## SDG&E October 18, 2011 Response A. 10-06-007 South Bay Substation Relocation Project PTC Energy Division Data Request 10 Dated October 7, 2011 SDGE-ED-10: Questions 1 & 2

1. **GIS Alternative:** In response to Question 1 in Data Request No. 8, SDG&E indicated that in order to reduce the overall costs associated with the GIS Alternative; the 138 kV line would remain overhead as long as it is determined to be technologically feasible and provided a proposed schematic showing tie-lines assuming overhead of the existing 138 kV.

## Figure 1: Detailed GIS Substation Project Components Map 1 of 3

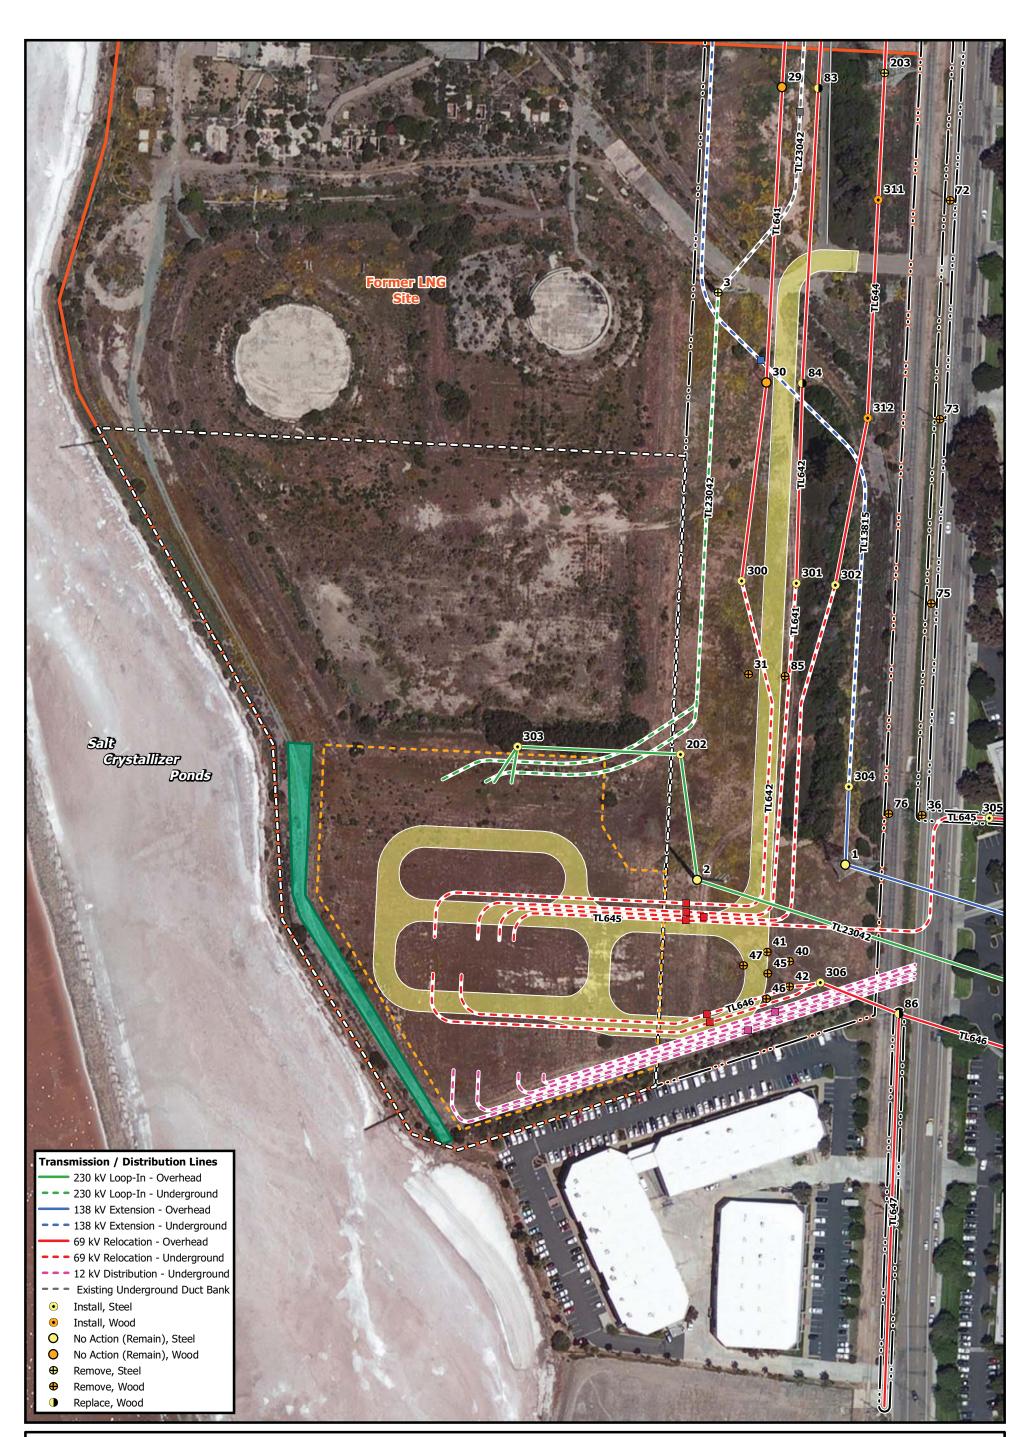
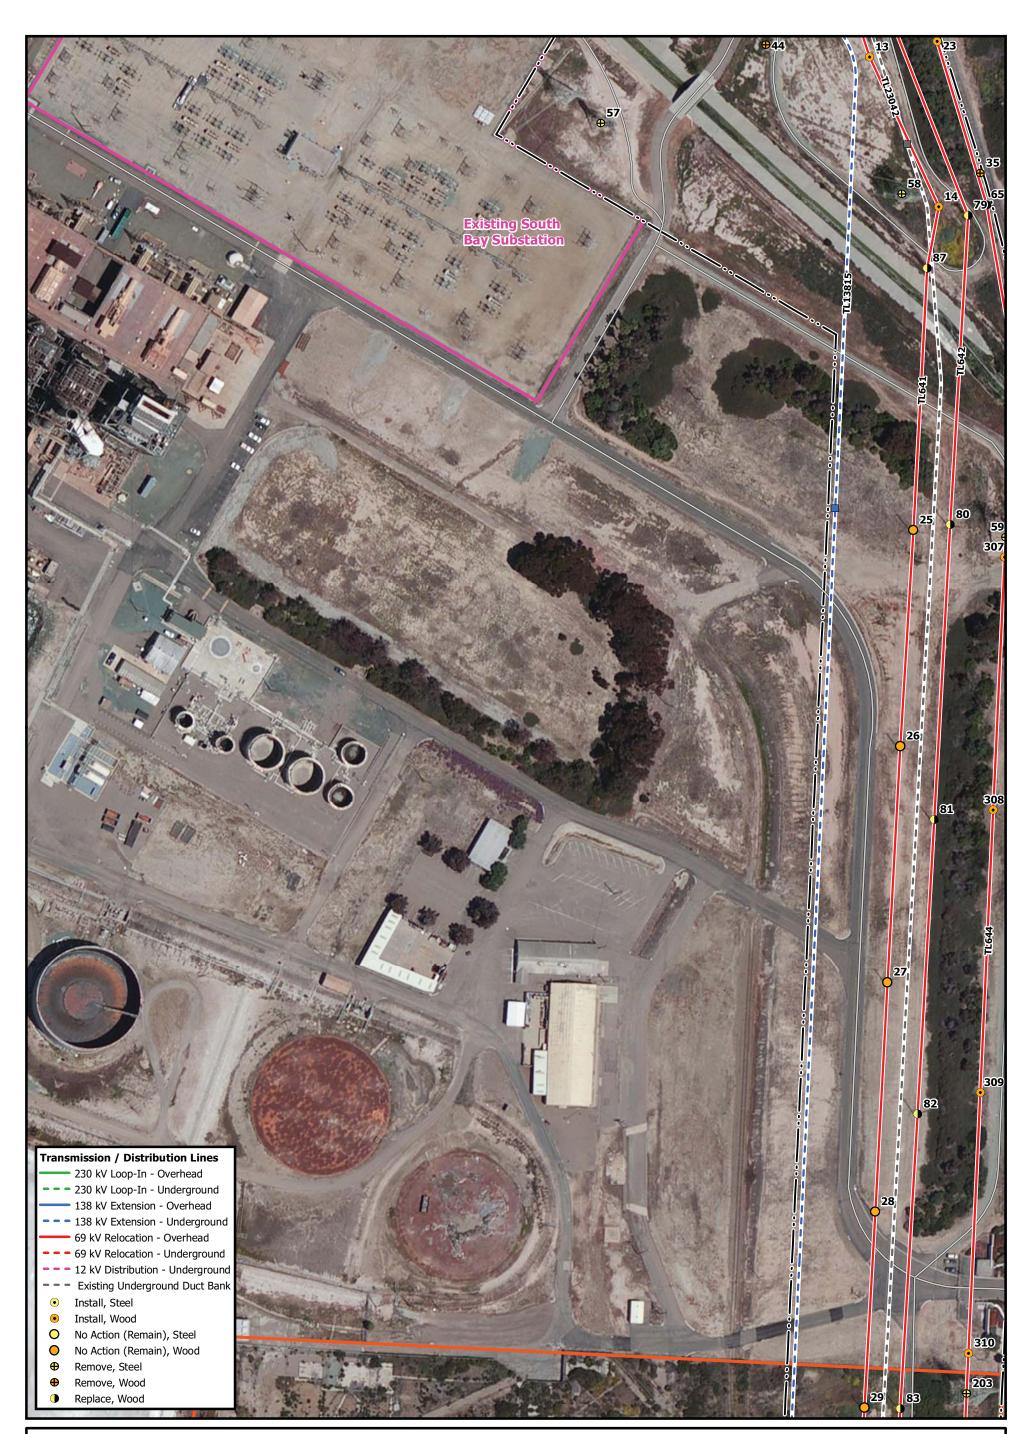
Please identify the approximate costs savings for SDG&E that would result in the event the 138 kV transmission line is to remain in the existing overhead configuration.

In Data Response No. 5 received by SDG&E on May 4, 2011, Section 2.1.2 stated the extension of the existing 138 kV alignment would occur in the same fashion for both the Proposed Project and GIS Alternative, which consists of undergrounding the 138 kV transmission line. Please provide a description of the proposed transmission line interconnections assuming undergrounding the 138 kV transmission line is determined to be technologically feasible. Please provide a map and ARC GIS shape files of the location of all transmission line interconnections that would be required with implementation of the GIS Substation Alternative that includes undergrounding the 138 kV transmission line.

The approximate cost savings of not undergrounding the 138kV transmission line is \$9-\$10 Million dollars.

The Gis shape files are attached to this email transmittal.
